STAFF REPORT
COMMUNITY DEVELOPMENT DEPARTMENT

HEARING DATE: 11/3/2022
 TO: Planning & Zoning Commission
 FROM: Joe Dodson, Associate Planner
 208-884-5533
 SUBJECT: H-2022-0064
 Hadler Neighborhood
 LOCATION: Located at 7200 S. Locust Grove Road, approximately 1/2 mile south of the Locust Grove and Lake Hazel intersection on the east side of Locust Grove, in the N 1/2 of the SW 1/4 of Section 5, Township 2N, Range 1E.

Request for Annexation and Zoning of approximately 20.5 acres of land from RUT to the R-15 zoning district and a Preliminary Plat consisting of 145 building lots (52 single-family attached lots & 93 detached single-family lots) and 11 common lots on approximately 20 acres of land in the requested R-15 zoning district, by Laren Bailey, Conger Group.

C. Landscape Plans (date: 7/29/2022)

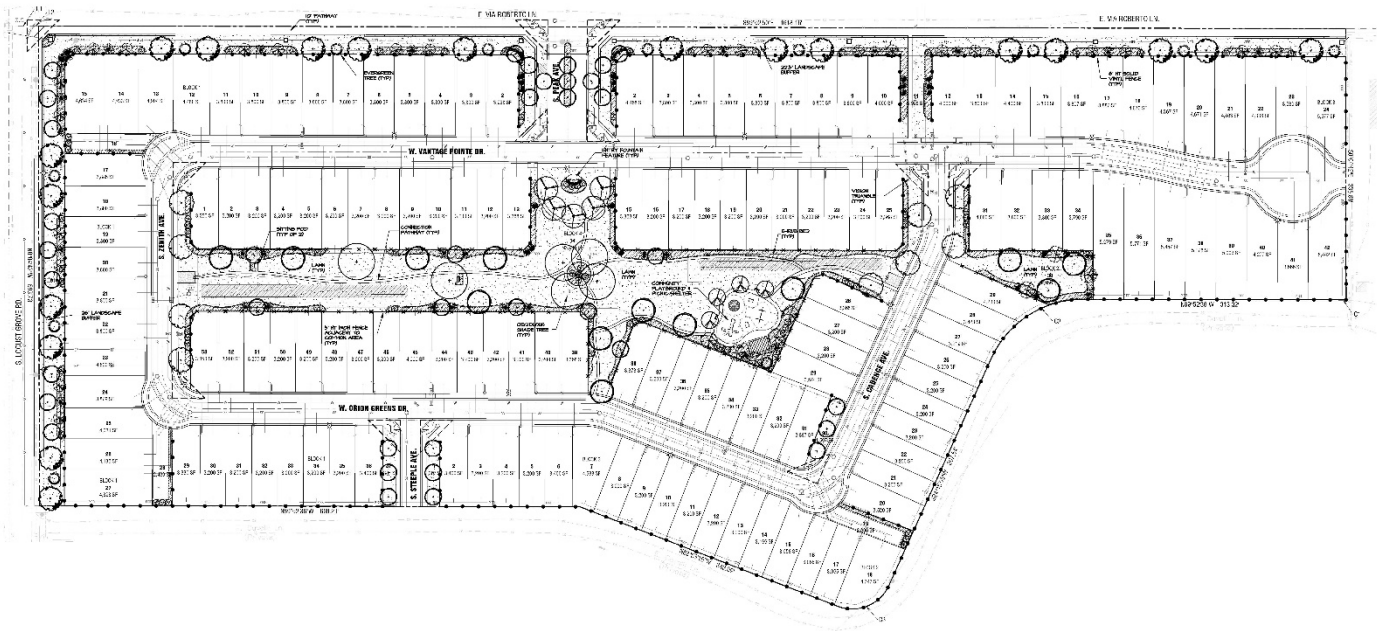
The pathway along Locust Grove appears to be attached to Locust Grove which does not comply with the UDC or Master Pathways Plan. So, the Applicant should revise the plat and landscape plan to depict this 10-foot pathway to be located within the required 25-foot buffer to Locust Grove and at least four (4) feet outside of the ultimate ROW to ensure the pathway remains detached.

Staff recommends the Applicant provide evidence these buffers are enhanced beyond the pathway, trees, and grasses. For example, boulders, additional vegetation, decorative elements, decorative fence/walls, additional micro-pathways, etc. The burden of proof for the proposed common open space to qualify falls on the Applicant and not on Staff.

3. The landscape plan included in Section VII.C, dated July 29, 2022, shall be revised as follows prior to submitting for Final Plat approval:
 - a. Revise the landscape plan to match the revisions made to the street section of Vantage Pointe Drive on the latest preliminary plat.

- b. Make the necessary revisions to the landscape plans to match the plat revisions noted above in VIII.A2.
 - c. Depict the 10-foot pathway along S. Locust Grove to be located within the required 25-foot street buffer and located at least four (4) feet outside of the ultimate ROW to ensure the pathway remains detached, consistent with UDC 11-3B-7C.1a.

D. Open Space Exhibit:

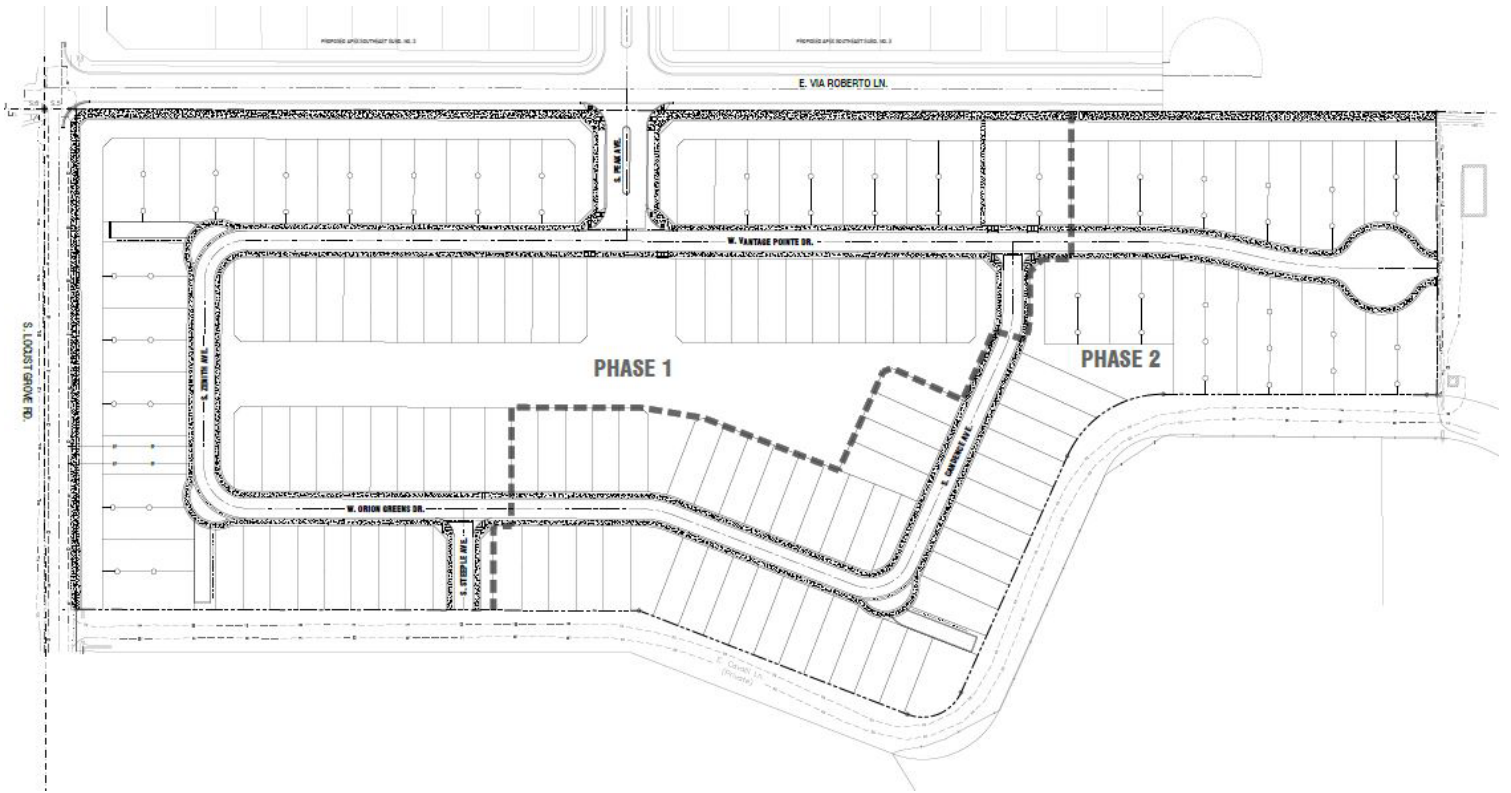
the smaller common open space area along the southeast boundary. However, Staff is not sure if the landscape buffers to the adjacent public streets meet the enhanced buffer requirements outlined in UDC 11-3G-3B.3 to count towards the open space. Previously, these areas automatically qualified towards the minimum open space but this is no longer the case with the latest open space code updates that desires for more than the minimum to be included within the required buffers in order to count towards the overall qualified open space for a project. The Applicant appears to comply with the first two points outlined in code but may not comply with the last two points: enhanced amenities with social interaction characteristics; and, enhanced context with the surroundings.

If these buffers do not count towards the minimum qualified open space, approximately 1 acre of land must be removed from the calculation leaving approximately 2.5 acres of qualified open space which does not comply with the minimum qualified open space requirement. Therefore, the Applicant should provide evidence that the proposed street buffers are qualified open space prior to the Commission hearing OR apply for Alternative Compliance to reduce the amount of qualified open space required due to the project's proximity to Discovery Park to the northeast.

4. Prior to the Commission hearing, the Applicant shall provide evidence that the proposed street buffers are qualified open space OR apply for Alternative Compliance prior to the City Council hearing to request a reduction to the amount of qualified open space required.

F. Common Drive Exhibits:

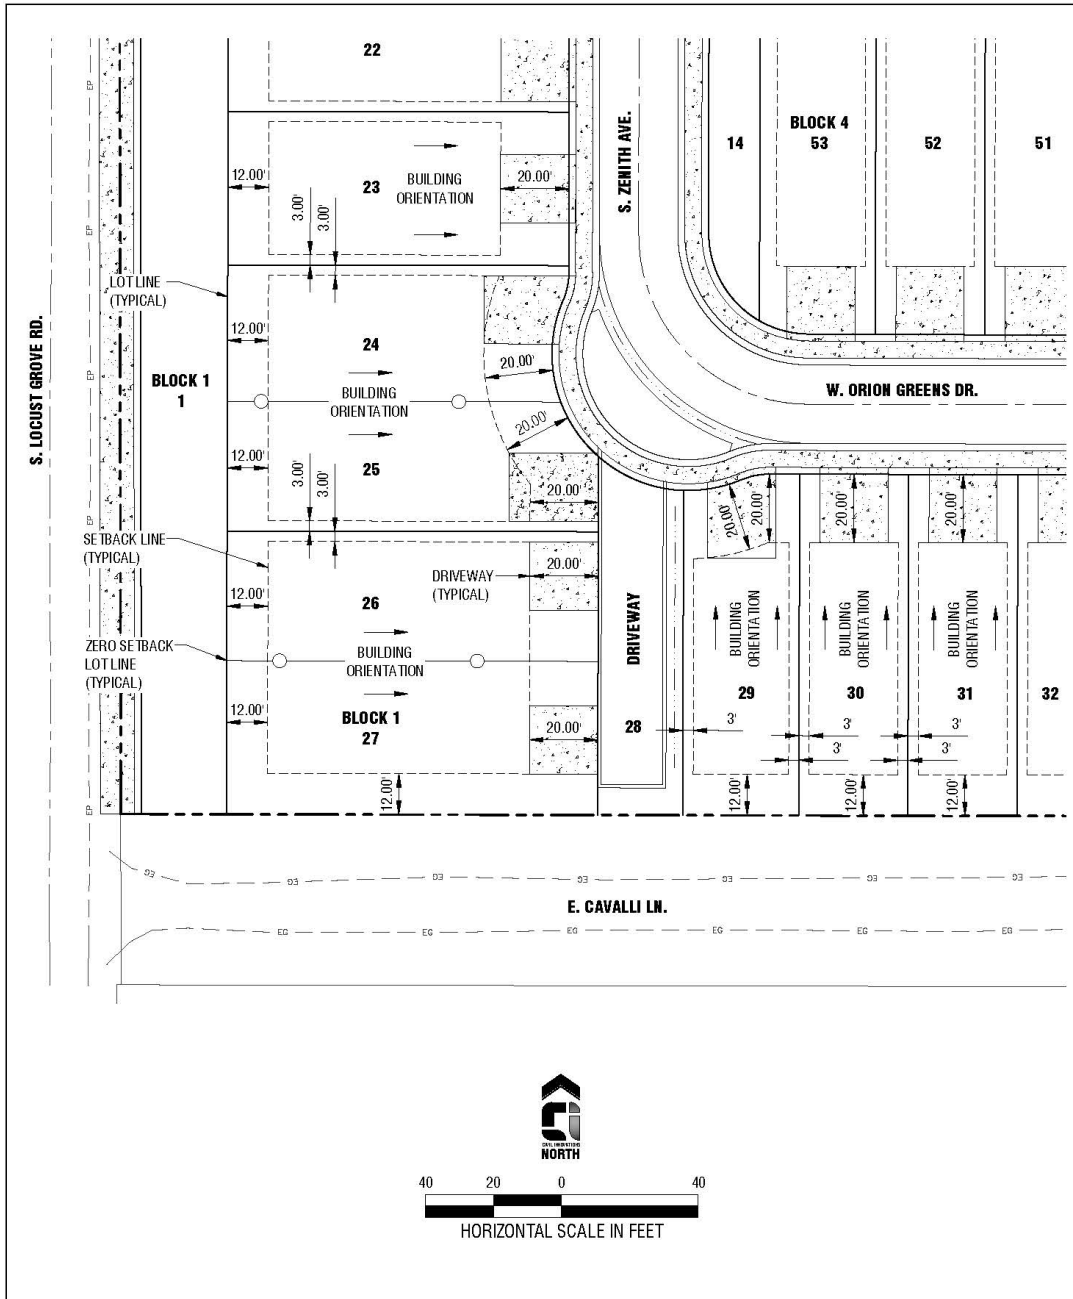
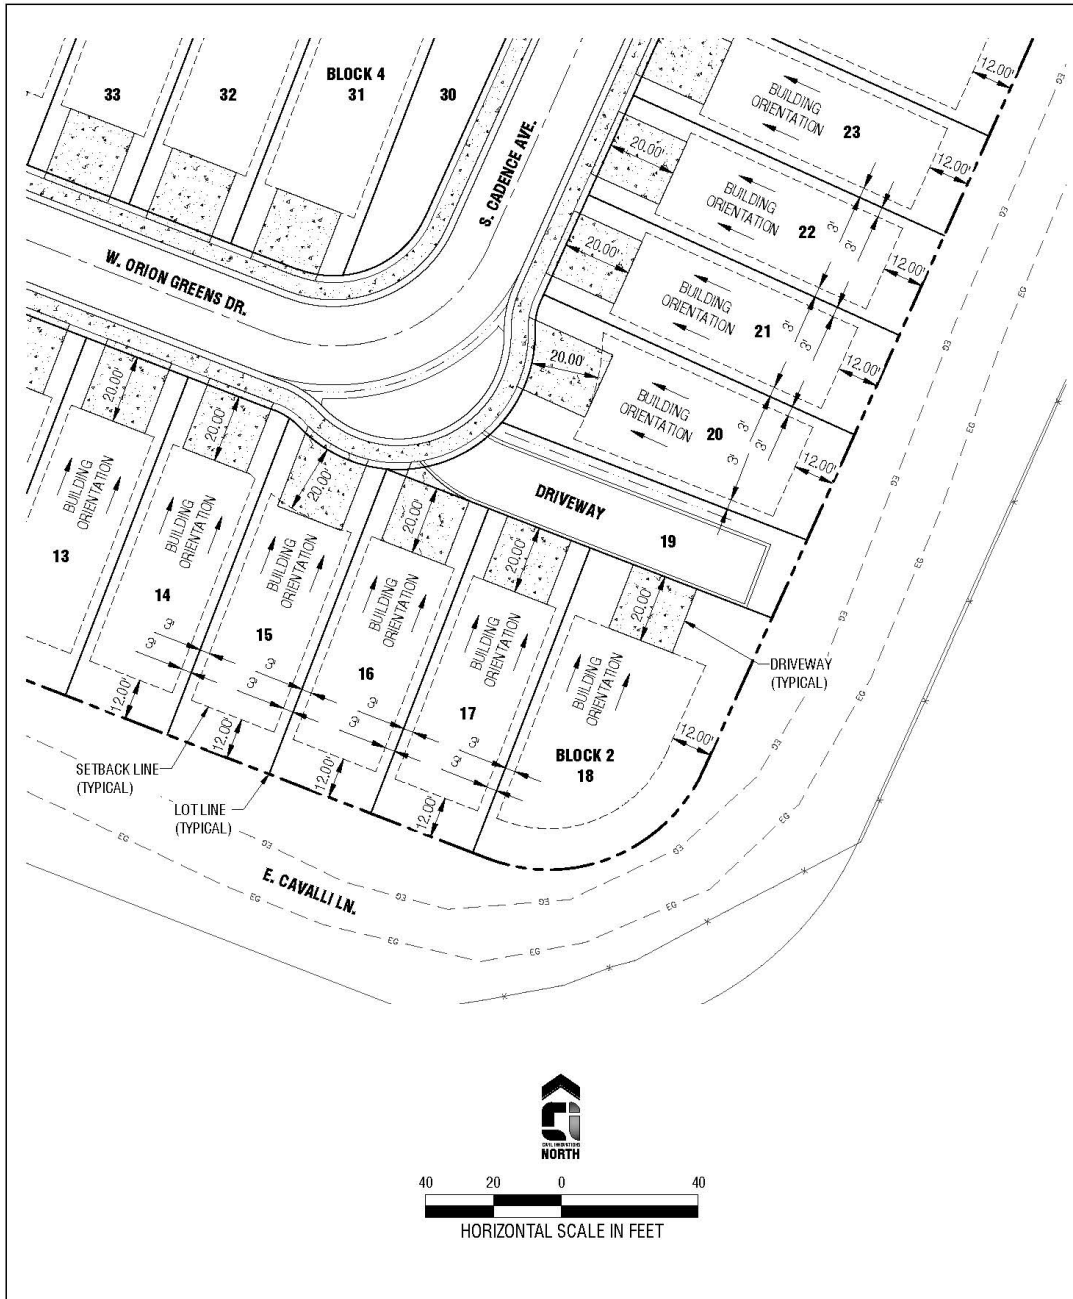
The three (3) proposed common drives depict 3 lots taking access from each of them and include at least 5 feet of landscaping adjacent to the abutting lot not taking access from the common drive. The proposed common drive design complies with UDC 11-6C-3D requirements.
